Gainesville Renewable Energy Center Completeness Responses and Amendment to the Site Certification Application

Re: Gainesville Renewable Energy Center
Site Certification Application (PPSA No. PA09-55)
Completeness Responses and Amendment to the Site Certification Application

The completeness responses are provided in response to the Florida Department of Environmental Protection (FDEP) Determination that Application is Incomplete dated January 11, 2010. The responses provide additional information and clarifications to the requests from the reviewing agencies, which were included with FDEP's determination of incompleteness. For certain agency requests, GREC LLC clearly indicates the reasons why the requested information is not provided. Also, as indicated in several of the responses, GREC LLC has concluded that certain completeness items may be more suitably addressed through postcertification submittals and has recommended conditions of certification for several of these requests.

FIGURE 4.2.0-3. (REVISED 1/28/10)
 DETAILED FACILITY LAYOUT FOR GREC

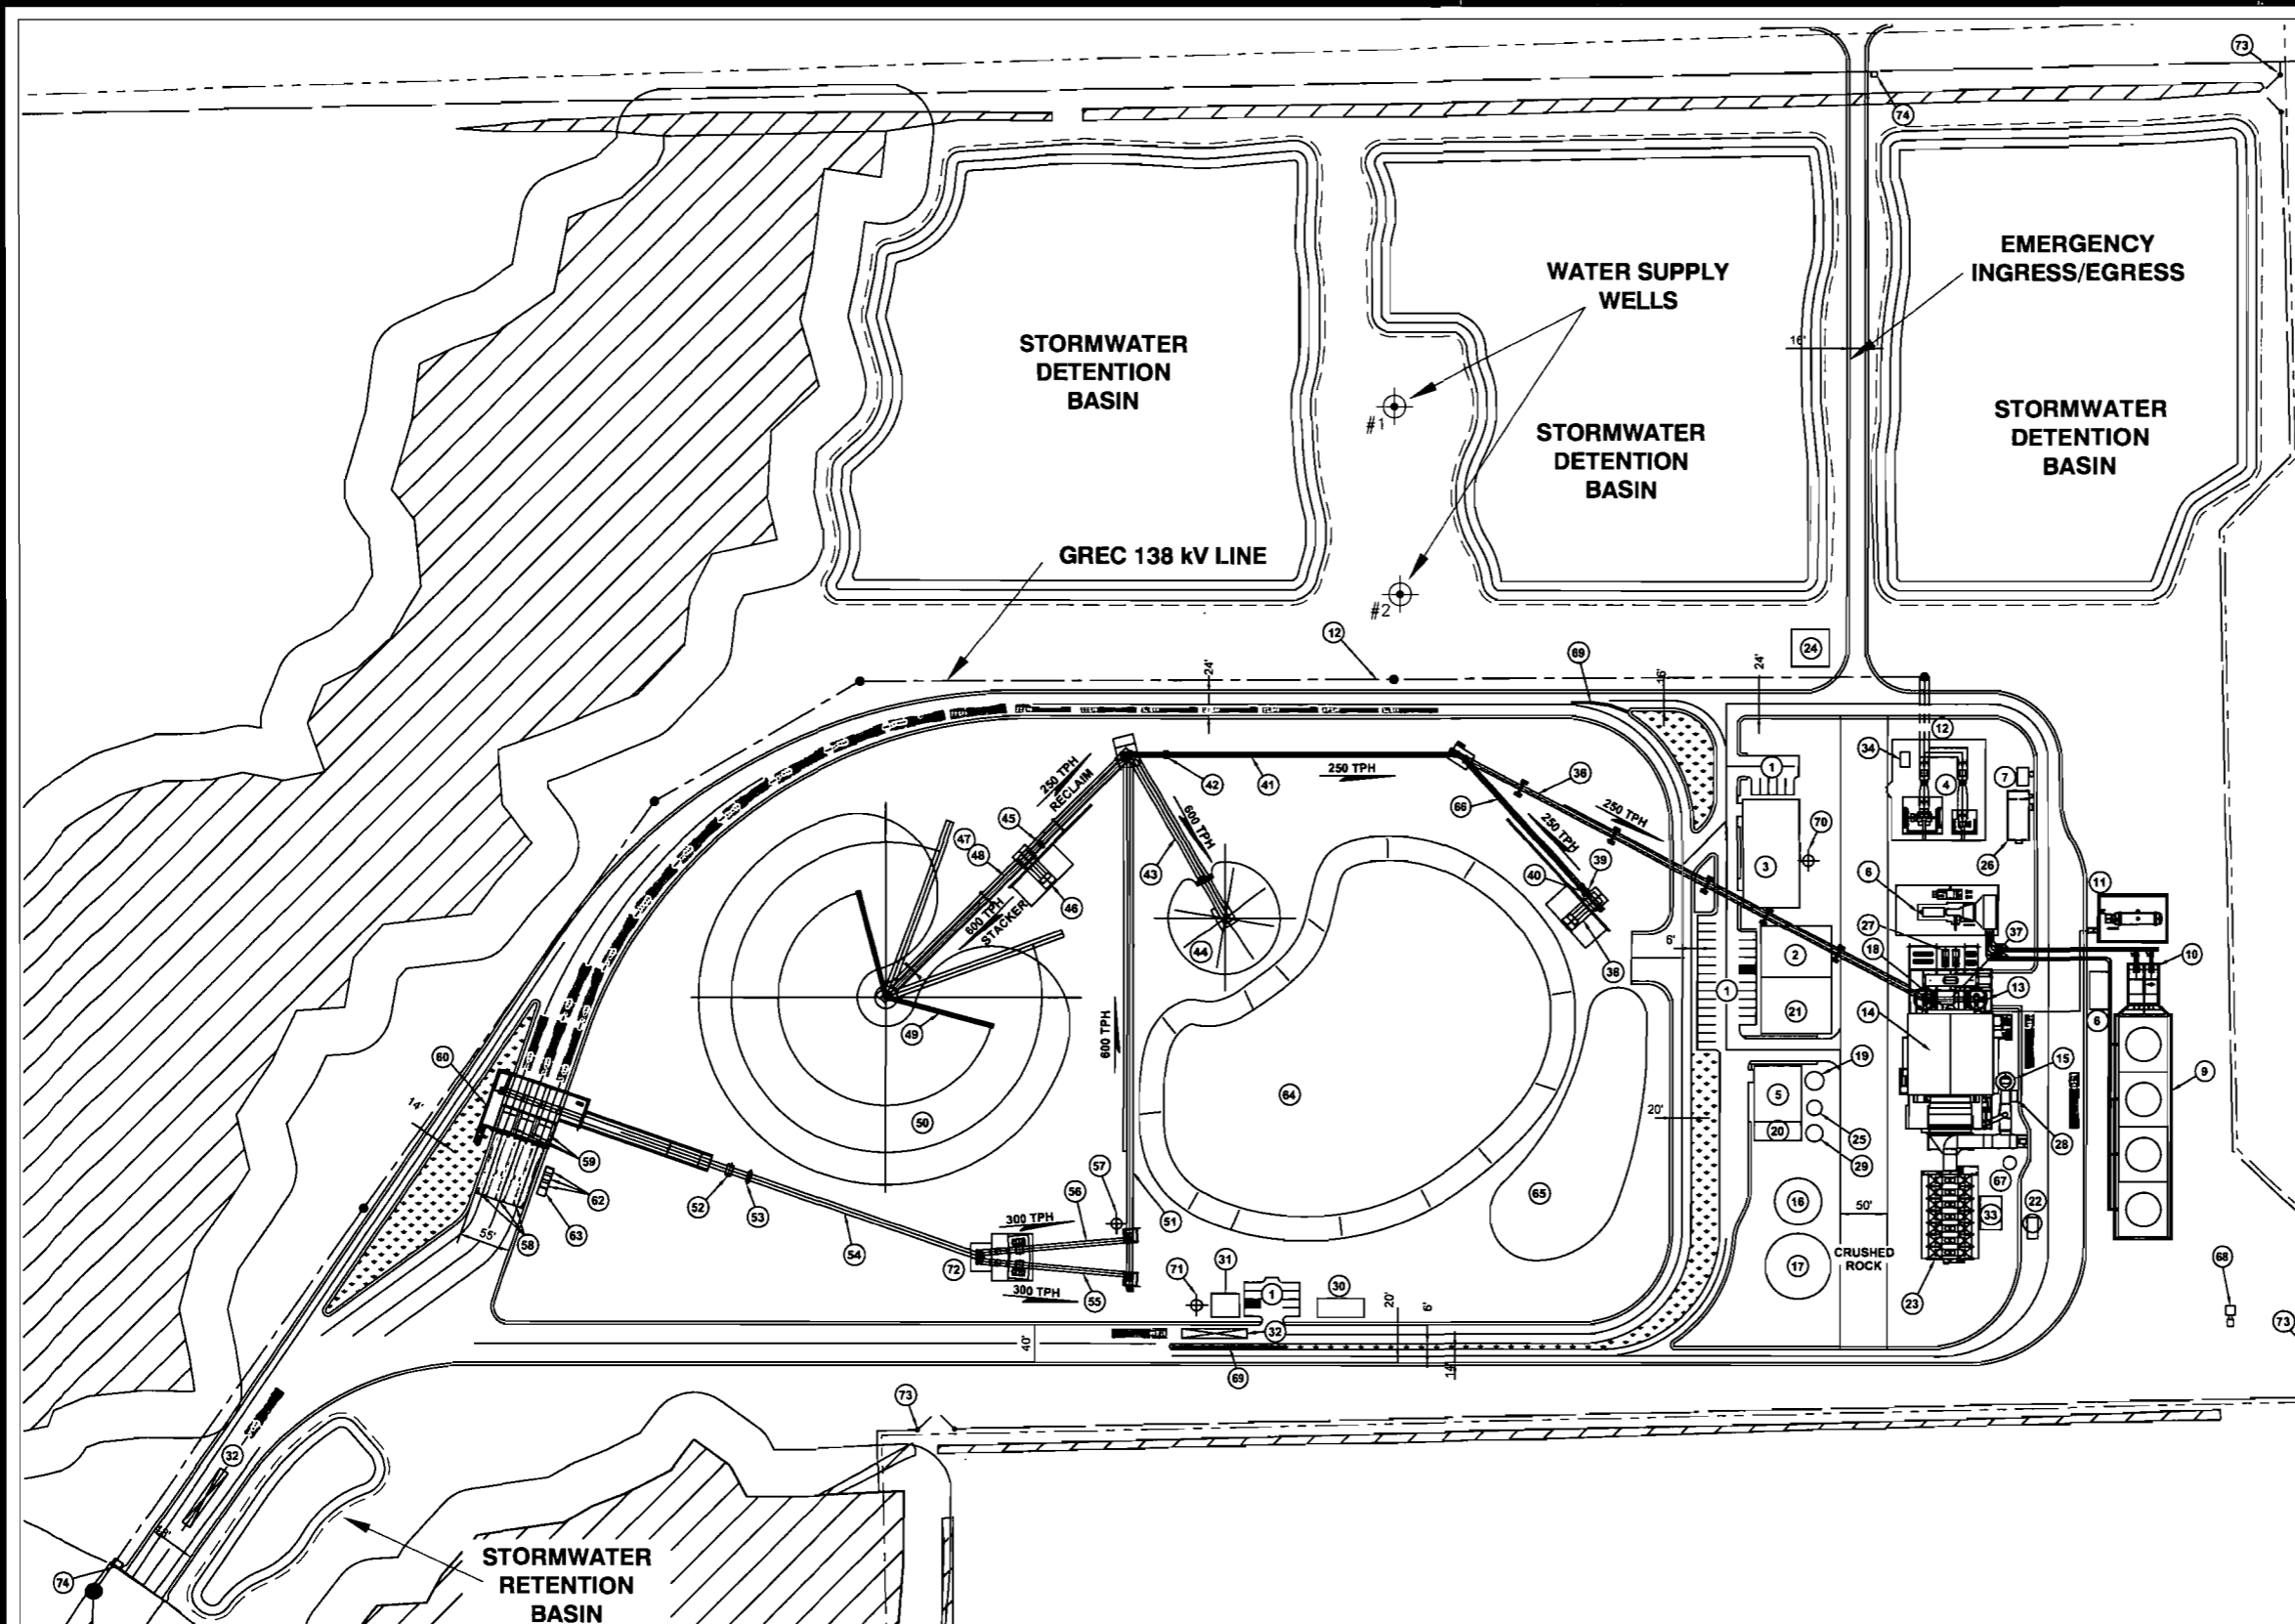
FDEPNEDGW-4 4) *On Figure 4.2.0-3, the Detailed Facility Layout does not seem to indicate a boiler blowdown or cooling tower blowdown holding area. Please address this issue and provide details of any applicable holding tanks\basins.*

FDEPNEDGW-8 8) Please clarify if runoff swales and ponds are proposed around the fuel storage areas, and provide details on Figure 4.2.0-3, or similar figure, including details of any liners. If no runoff swales or ponds are proposed, then provide details of fuel storage area design that prohibits runoff. Use of a layer of compacted wood chips above the clay liner would not provide a sufficient barrier.

See response to item FDEPNEDGW-1.

- The biomass fuel truck unloading shed and associated facilities will be relocated. With reference to Figure 4.2.0-3, Detailed Facility Layout for GREC, on page 4-11 of the GREC SCA compared to the revised Figure 4.2.0-3, the
